Cagnon Ground Storage Tank Replacement Project
Solicitation Number: CO-00436-SM
Job No.: 20-6010

ADDENDUM 3
9/21/2021

SAN ANTONIO WATER SYSTEMS
CAGNON RD GROUND STORAGE TANK
REPLACEMENT PROJECT
PUMP STATION SUCTION
HEADER

C-311

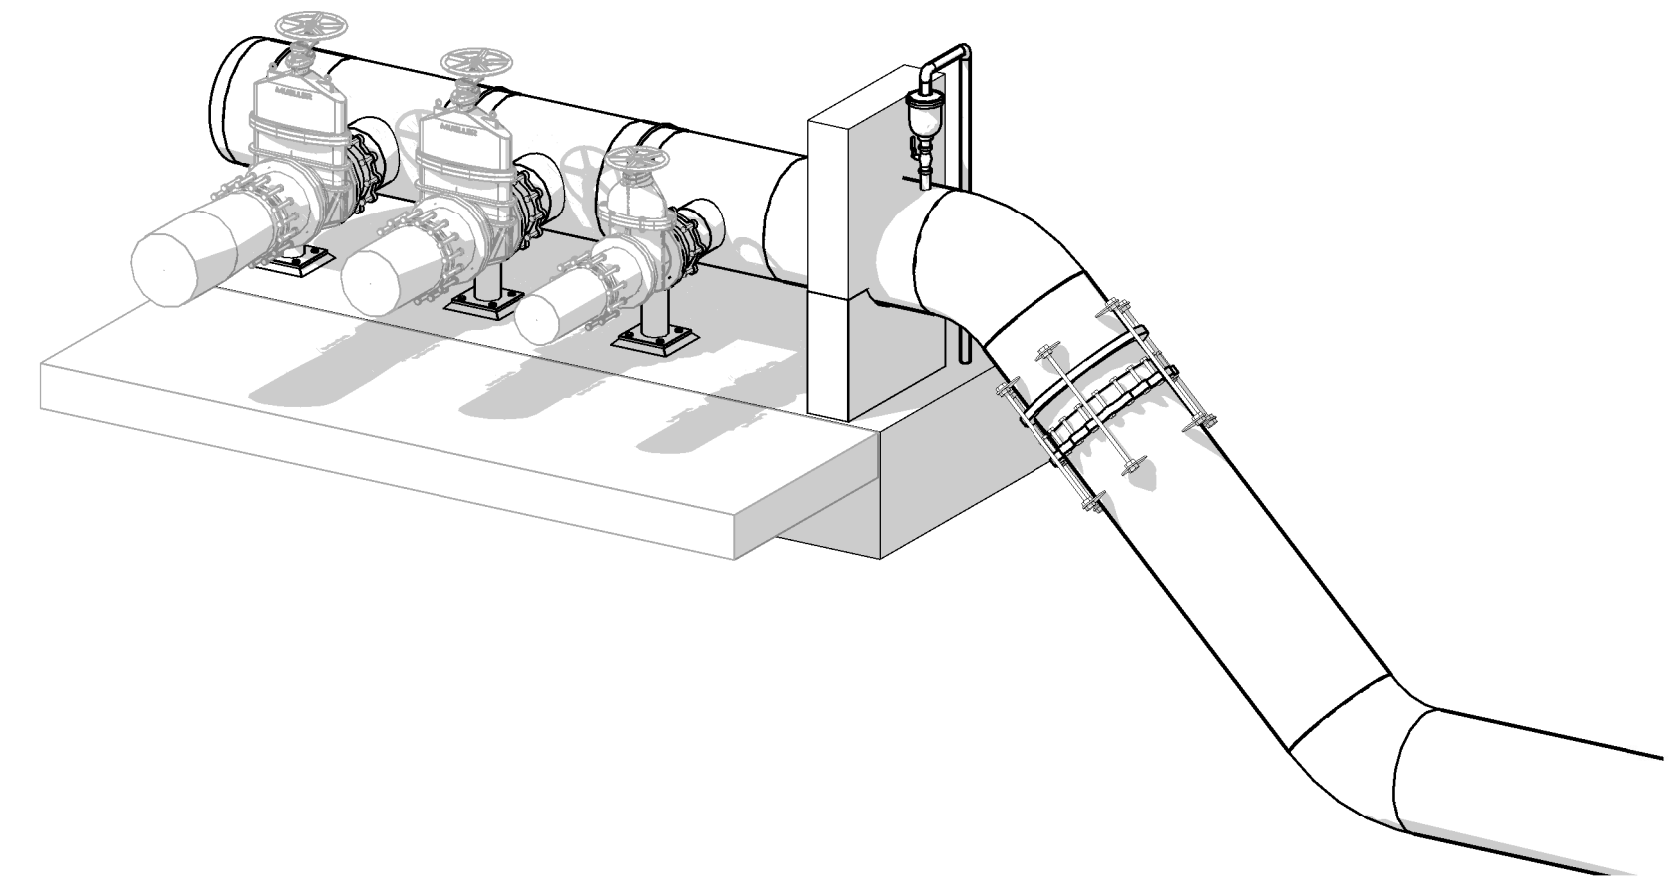
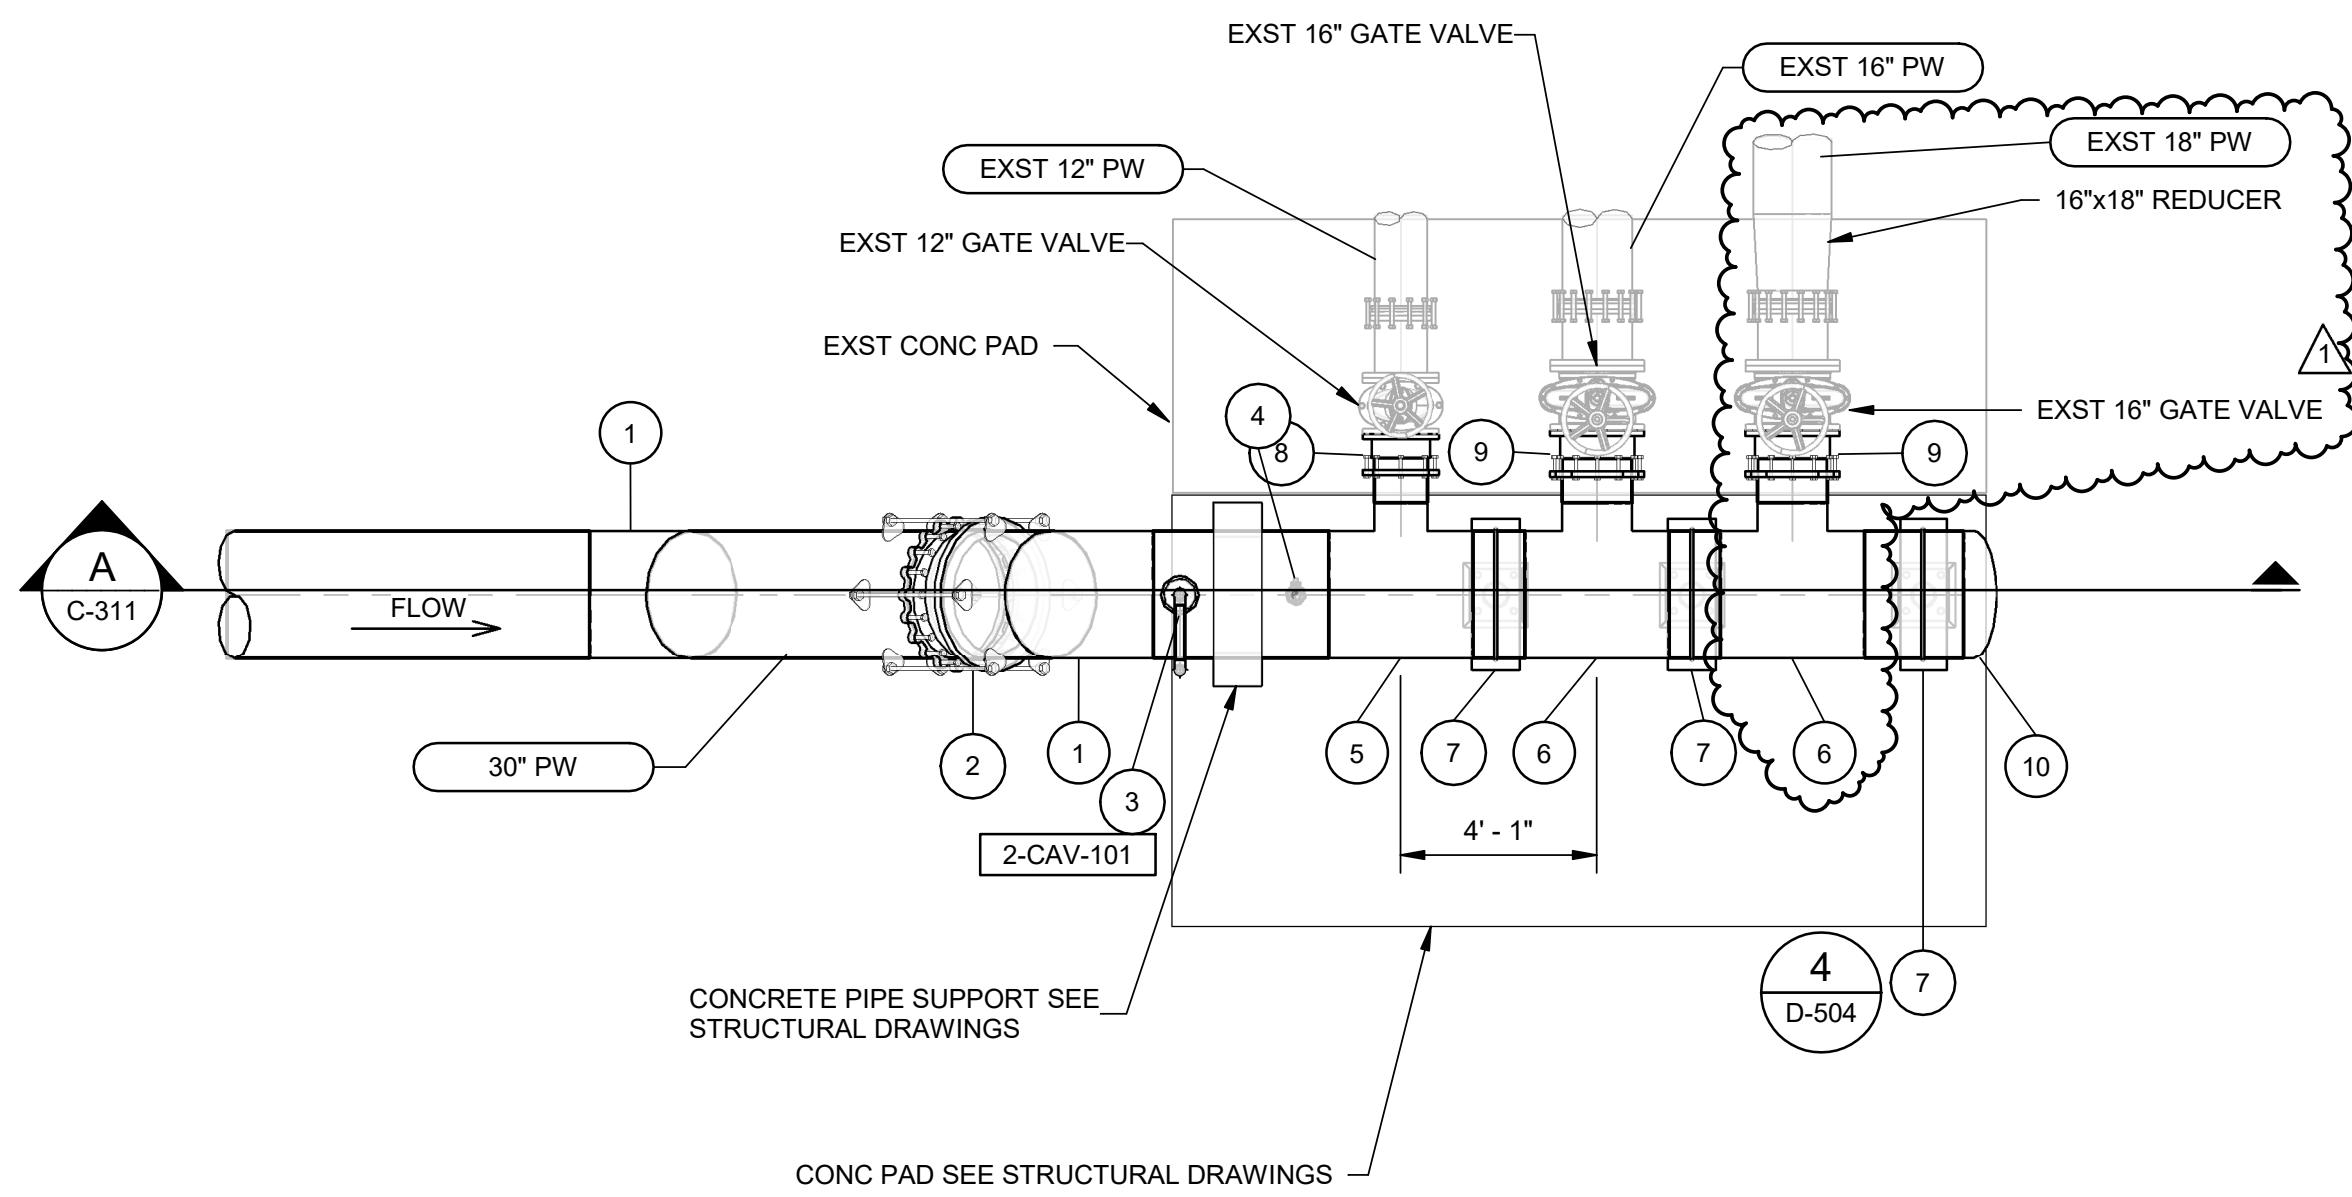
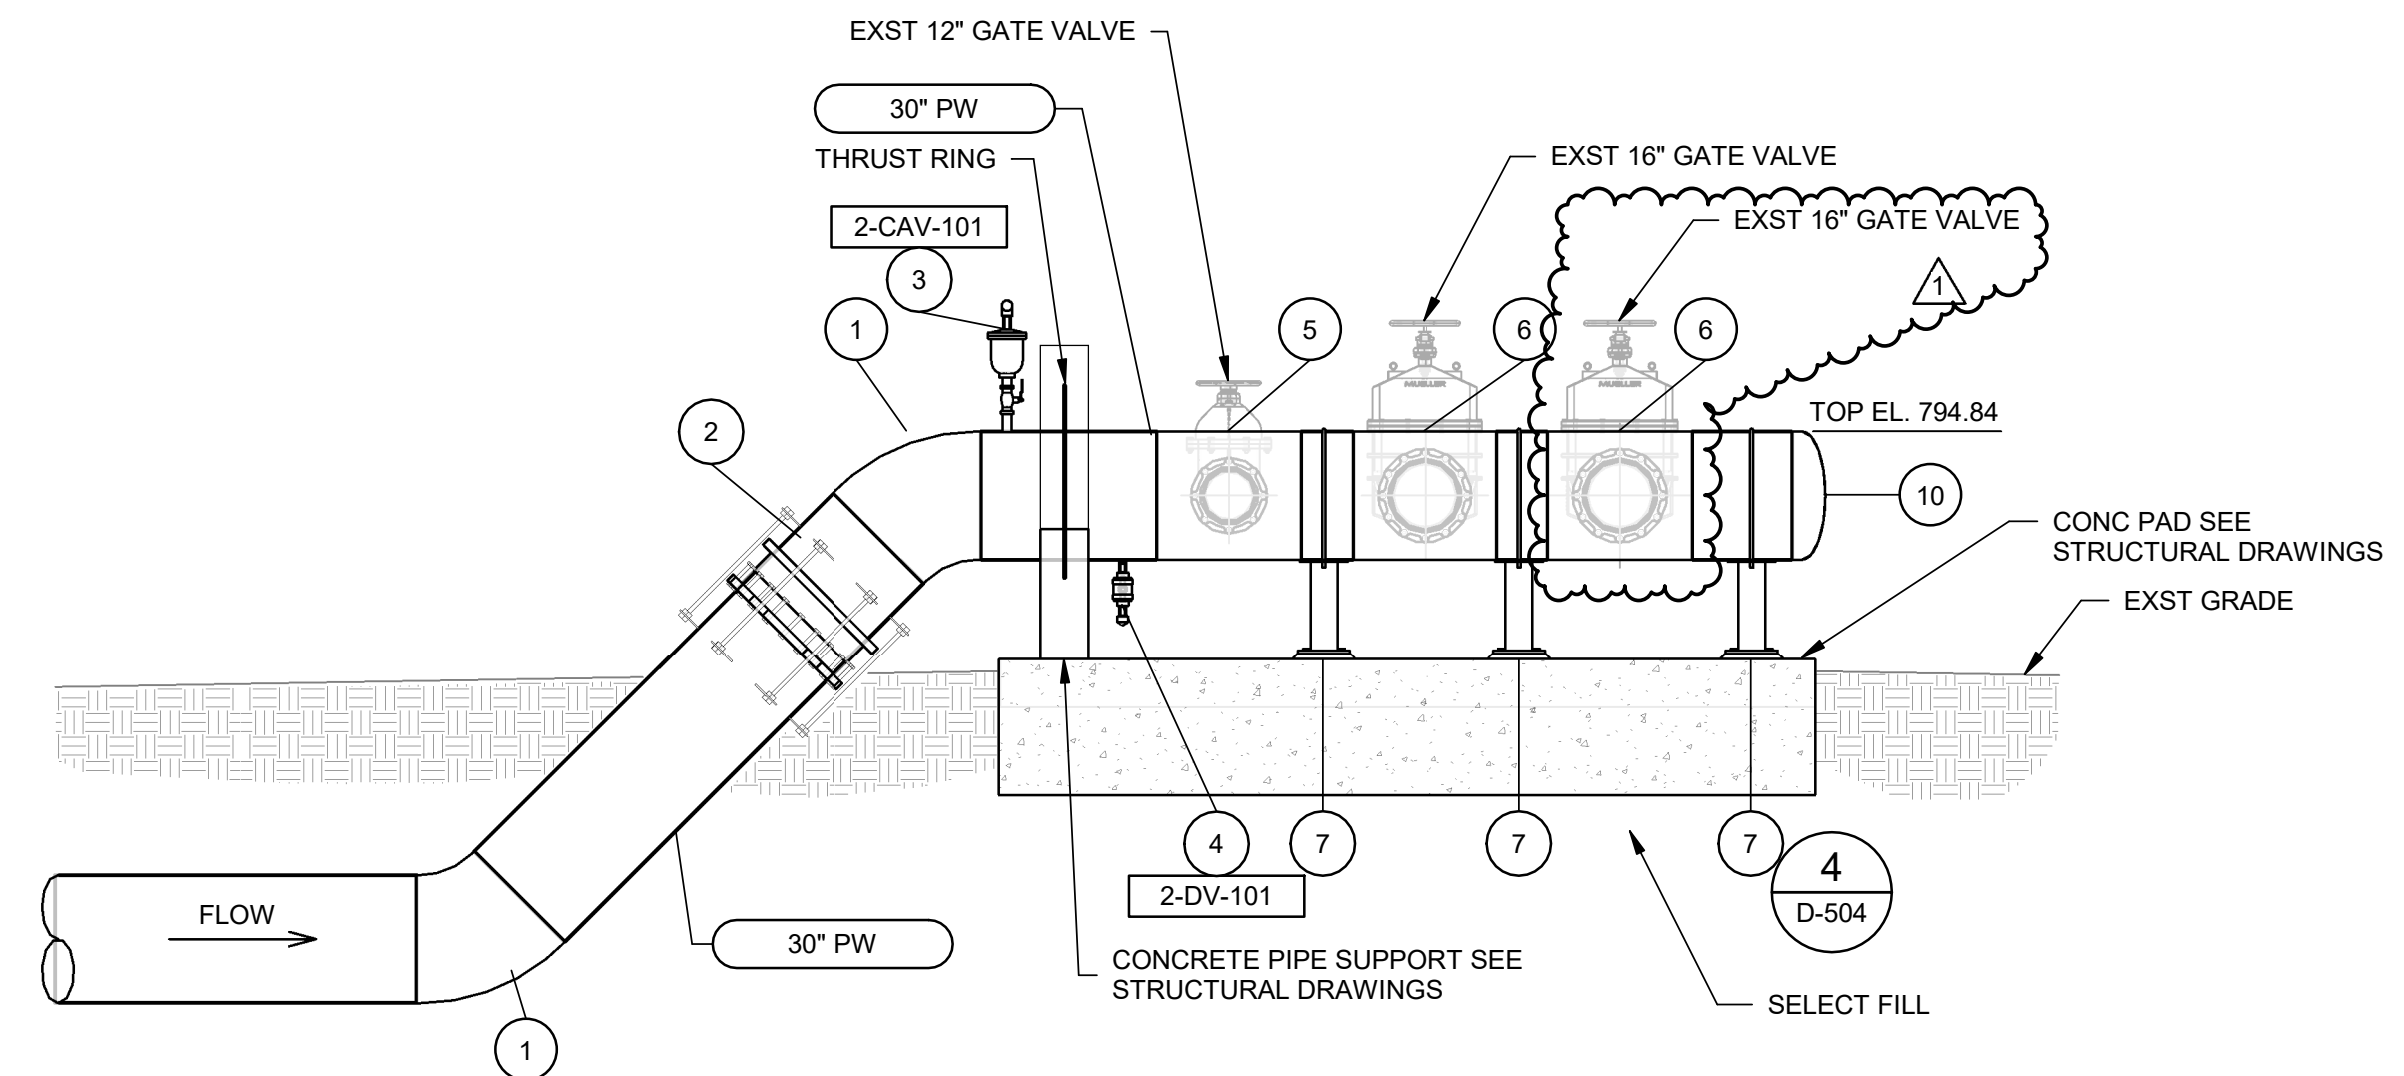
1. REMOVE Drawing C-311 – Pump Station Suction Header in its entirety from Plan Set and REPLACE with the attached drawing.

EXISTING VALVES TO REMAIN.
CLOSE AND PROTECT VALVES
DURING CONSTRUCTION.
SEE NOTE 2

1. THE SLAB SHALL BE MINIMUM 4" ABOVE FINISHED GRADE. SEE STRUCTURAL DRAWING SHT S-106 FOR SLAB DESIGN.
2. ISOLATE CONNECTION TO TANK AND PLUG/CAP EXISTING GATE VALVES PRIOR TO TANK DEMOLITION. PROTECT EXISTING PUMPS, VALVES AND ALL REMAINING PIPING DURING DEMOLITION AND CONSTRUCTION.
3. VERIFY ELEVATIONS AND DIMENSIONS FOR THE EXISTING ABOVE GRADE SUCTION HEADER.
